## City of Ketchum

**Recommendation to Hold a Public Hearing and Approve the Ketchum Townsite: Block 82, Lot 13A Lot Line Shift Final Plat & Findings of Fact, Conclusions of Law, and Decision.**

Ketchum Townsite: Block 82 Lot  
13A

IN RE:	)	
	)	
Ketchum Townsite Block 82 Lot Line Shift	)	<b>KETCHUM CITY COUNCIL</b>
Lot Line Shift	)	<b>FINDINGS OF FACT, CONCLUSIONS OF LAW, AND</b>
Date: February 22, 2022	)	<b>DECISION</b>
	)	
File Number: P21-099	)

### KETCHUM TOWNSITE: BLOCK 82, LOT 13A

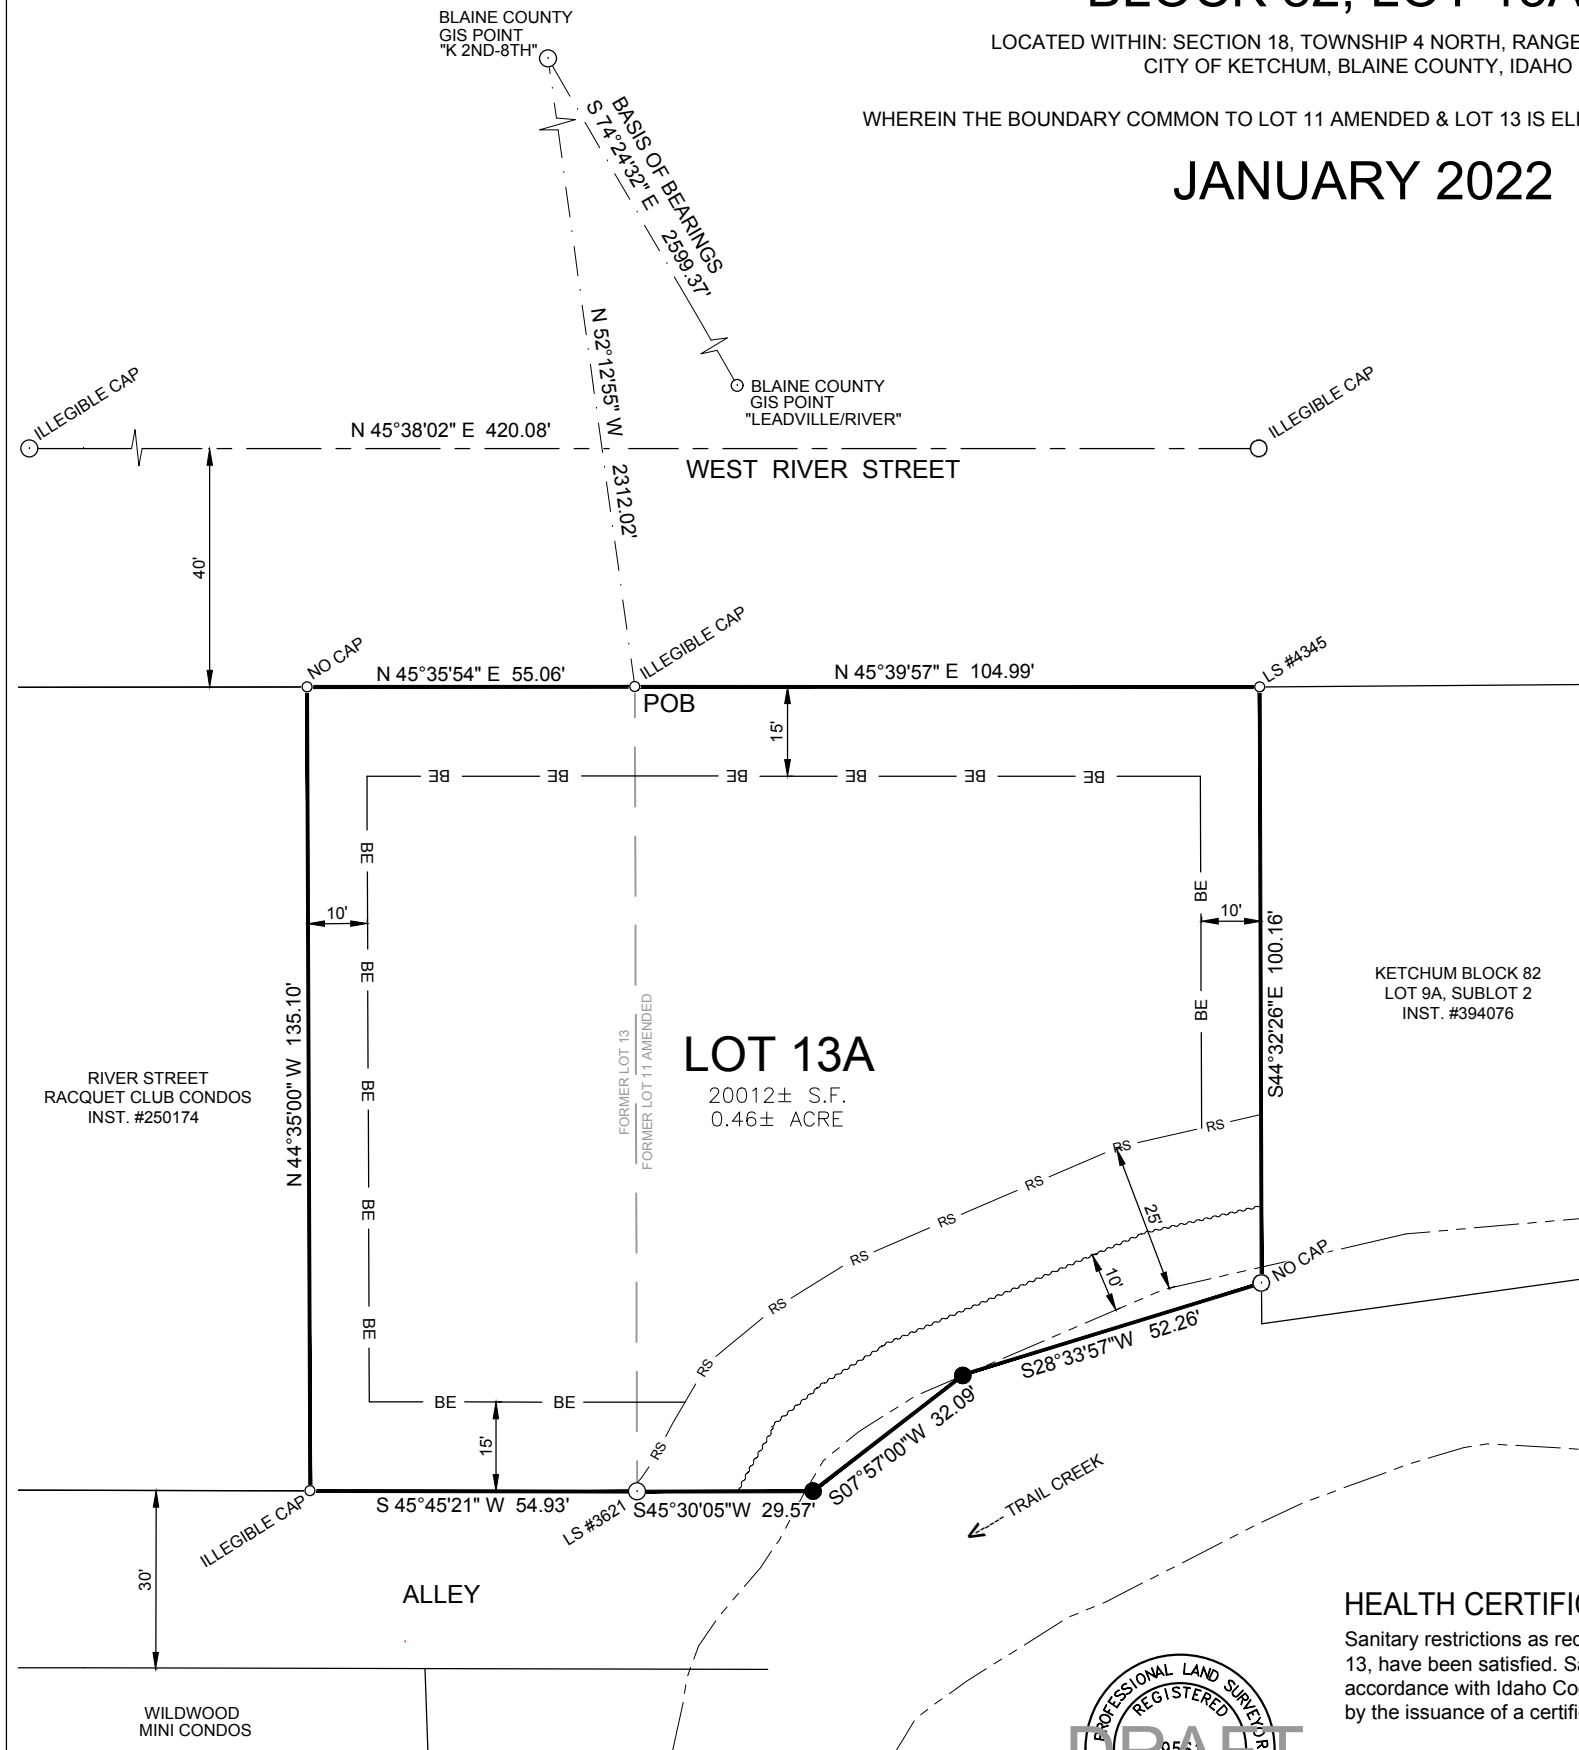
<input checked="" type="checkbox"/>	<input type="checkbox"/>	<input type="checkbox"/>	16.04.030.K.1	<p><b>Point of beginning of subdivision description tied to at least two (2) governmental survey corners, or in lieu of government survey corners, to monuments recognized by the city engineer.</b></p> <p><b>Council Findings</b> <i>As conditioned, this standard shall be met. The plat mylar shall show a minimum of two Blaine County Survey Control Monuments with ties to the property and an inverse between the two monuments. The Survey Control Monuments shall be clearly identified on the face of the map.</i></p>
<input checked="" type="checkbox"/>	<input type="checkbox"/>	<input type="checkbox"/>	16.04.030.K.2	<p><b>Location and description of monuments.</b></p> <p><i>As conditioned, this standard shall be met. The final plat mylar shall show the location and description of monuments.</i></p>
<input checked="" type="checkbox"/>	<input type="checkbox"/>	<input type="checkbox"/>	16.04.030.K.3	<p><b>Tract boundary lines, property lines, lot lines, street right of way lines and centerlines, other rights of way and easement lines, building envelopes as required on the final plat, lot area of each lot, boundaries of floodplain and floodway and avalanche district, all with bearings, accurate dimensions in feet and decimals, in degrees and minutes and radii, arcs, central angles, tangents and chord lengths of all curves to the above accuracy.</b></p> <p><b>Council Findings</b> <i>The plat indicates West River Street as well as the building envelope and Riparian and Fisherman's &amp; Nature Study easements. The floodway &amp; floodplain lines are shown on the plat.</i></p>

<input checked="" type="checkbox"/>	<input type="checkbox"/>	<input type="checkbox"/>	<b>16.04.030.K.4</b>	<b>Names and locations of all adjoining subdivisions.</b>
			<b>Council Findings</b>	<i>The plat lists the adjacent River Street Racquet Club Condos &amp; Wildwood Mini Condos.</i>
<input checked="" type="checkbox"/>	<input type="checkbox"/>	<input type="checkbox"/>	<b>16.04.030.K.5</b>	<b>Name and right of way width of each street and other public rights of way.</b>
			<b>Council Findings</b>	<i>This standard has been met. The plat indicates the River Street public rights-of-way.</i>
<input checked="" type="checkbox"/>	<input type="checkbox"/>	<input type="checkbox"/>	<b>16.04.030.K.6</b>	<b>Location, dimension and purpose of all easements, public or private.</b>
			<b>Council Findings</b>	<i>This standard has been met. The plat indicates the riparian &amp; scenic easement along with the fisherman's &amp; nature study easement.</i>

<input checked="" type="checkbox"/>	<input type="checkbox"/>	<input type="checkbox"/>	<b>16.04.030.K.7</b>	<b>The blocks numbered consecutively throughout each block.</b>
			<b>Council Findings</b>	<i>This standard has been met.</i>
<input type="checkbox"/>	<input type="checkbox"/>	<input checked="" type="checkbox"/>	<b>16.04.030.K.8</b>	<b>The outline of any property, other than a street, alley or easement, which is offered for dedication to public use, fully dimensioned by distances and bearings with the area marked "Dedicated to the City of Ketchum for Public Use", together with any other descriptive language with regard to the precise nature of the use of the land so dedicated.</b>
			<b>Council Findings</b>	<i>N/A as no new dedication is being proposed.</i>
<input checked="" type="checkbox"/>	<input type="checkbox"/>	<input type="checkbox"/>	<b>16.04.030.K.9</b>	<b>The title, which shall include the name of the subdivision, the name of the city, if appropriate, county and state, and the location and description of the subdivision referenced to section, township, range.</b>

<b>Council Findings</b>	<i>This standard has been met.</i>
<input checked="" type="checkbox"/>	<input type="checkbox"/>	<input type="checkbox"/>	<b>16.04.030.K.10</b>	<b>Scale, north arrow and date.</b>
				<i>This standard has been met.</i>
<input checked="" type="checkbox"/>	<input type="checkbox"/>	<input type="checkbox"/>	<b>16.04.030.K.11</b>	<b>Location, width, and names of all existing or dedicated streets and other public ways within or adjacent to the proposed subdivision</b>
			<b>Council Findings</b>	<i>This standard has been met. West River Street is indicated on the subdivision plat.</i>
<input type="checkbox"/>	<input type="checkbox"/>	<input checked="" type="checkbox"/>	<b>16.04.030.K.12</b>	<b>A provision in the owner's certificate referencing the county recorder's instrument number where the condominium declaration(s) and/or articles of incorporation of homeowners' association governing the subdivision are recorded.</b>

<b>Council Findings</b>	<i>As conditioned, this standard will be met prior to recordation of the Final Plat. The signature block page shall include a certificate of ownership and associated acknowledgement from all owners and holders of security interest with regard to the subject property, which shall be signed following Ketchum City Council review and approval of the application and prior to recordation of the Final Plat.</i>
<input checked="" type="checkbox"/>	<input type="checkbox"/>	<input type="checkbox"/>	<b>16.04.030.K.16</b>	<b>Certification and signature of engineer (surveyor) verifying that the subdivision and design standards meet all city requirements.</b>
			<b>Council Findings</b>	<i>As conditioned, this standard will be met prior to recordation of the Final Plat. The signature block page shall include the certification and signature of the surveyor verifying that the subdivision and design standards meet all City requirements.</i>

<b>Council Findings</b>	<i>The applicant shall meet the required monumentation standards prior to recordation of the Final Plat.</i>
<input checked="" type="checkbox"/>	<input type="checkbox"/>	<input type="checkbox"/>	16.04.040.F	<p><b>Lot Requirements:</b></p> <ol style="list-style-type: none"> <li>1. Lot size, width, depth, shape and orientation and minimum building setback lines shall be in compliance with the zoning district in which the property is located and compatible with the location of the subdivision and the type of development, and preserve solar access to adjacent properties and buildings.</li> <li>2. Whenever a proposed subdivision contains lot(s), in whole or in part, within the floodplain, or which contains land with a slope in excess of twenty five percent (25%), based upon natural contours, or creates corner lots at the intersection of two (2) or more streets, building envelopes shall be shown for the lot(s) so affected on the preliminary and final plats. The building envelopes shall be located in a manner designed to promote harmonious development of structures, minimize congestion of structures, and provide open space and solar access for each lot and structure. Also, building envelopes shall be located to promote access to the lots and maintenance of public utilities, to minimize cut and fill for roads and building foundations, and minimize adverse impact upon environment, watercourses and topographical features. Structures may only be built on buildable lots. Lots shall only be created that meet the definition of "lot, buildable" in section 16.04.020 of this chapter. Building envelopes shall be established outside of hillsides of twenty five percent (25%) and greater and outside of the floodway. A waiver to this standard may only be considered for the following: <ol style="list-style-type: none"> <li>a. For lot line shifts of parcels that are entirely within slopes of twenty five percent (25%) or greater to create a reasonable building envelope, and mountain overlay design review standards and all other city requirements are met.</li> <li>b. For small, isolated pockets of twenty five percent (25%) or greater that are found to be in compliance with the purposes and standards of the mountain overlay district and this section.</li> </ol> </li> <li>3. Corner lots outside of the original Ketchum Townsite shall have a property line curve or corner of a minimum radius of twenty five feet (25') unless a longer radius is required to serve an existing or future use.</li> <li>4. Side lot lines shall be within twenty degrees (20°) to a right angle or radial line to the street line.</li> <li>5. Double frontage lots shall not be created. A planting strip shall be provided along the boundary line of lots adjacent to arterial streets or incompatible zoning districts.</li> <li>6. Every lot in a subdivision shall have a minimum of twenty feet (20') of frontage on a dedicated public street or legal access via an easement of twenty feet (20') or greater in width. Easement shall be recorded in the office of the Blaine County recorder prior to or in conjunction with recordation of the final plat. Minimum lot sizes in all cases shall be reversed frontage lot(s).</li> </ol>

<b>Council Findings</b>	<i>Standard #1 and #2 have been met. Lot 13A complies with the dimensional standards required for lots within the T Zone. Standards #3-6 are not applicable</i>
<input type="checkbox"/>	<input type="checkbox"/>	<input checked="" type="checkbox"/>	16.04.040.G	<p><b>G. Block Requirements:</b> The length, width and shape of blocks within a proposed subdivision shall conform to the following requirements:</p> <ol style="list-style-type: none"> <li>1. No block shall be longer than one thousand two hundred feet (1,200'), nor less than four hundred feet (400') between the street intersections, and shall have sufficient depth to provide for two (2) tiers of lots.</li> <li>2. Blocks shall be laid out in such a manner as to comply with the lot requirements.</li> <li>3. The layout of blocks shall take into consideration the natural topography of the land to promote access within the subdivision and minimize cuts and fills for roads</li> </ol>

<p>shall be built in order to protect the natural vegetation and wildlife along the riverbank and to protect structures from damage or loss due to riverbank erosion.</p> <p>5. No ditch, pipe or structure for irrigation water or irrigation wastewater shall be constructed, rerouted or changed in the course of planning for or constructing required improvements within a proposed subdivision unless same has first been approved in writing by the ditch company or property owner holding the water rights. A written copy of such approval shall be filed as part of required improvement construction plans.</p> <p>6. Nonvehicular transportation system easements including pedestrian walkways, bike paths, equestrian paths, and similar easements shall be dedicated by the subdivider to provide an adequate nonvehicular transportation system throughout the City.</p>
			<p><b>Council Findings</b> A fish &amp; nature study easement as well as a scenic easement have been shown on the plat. Standards #1-2 and #5-6 are not applicable.</p>

3. The recorded plat shall show a minimum of two Blaine County Survey Control Monuments with ties to the property and an inverse between the two monuments. The Survey Control Monuments shall be clearly identified on the face of the map.
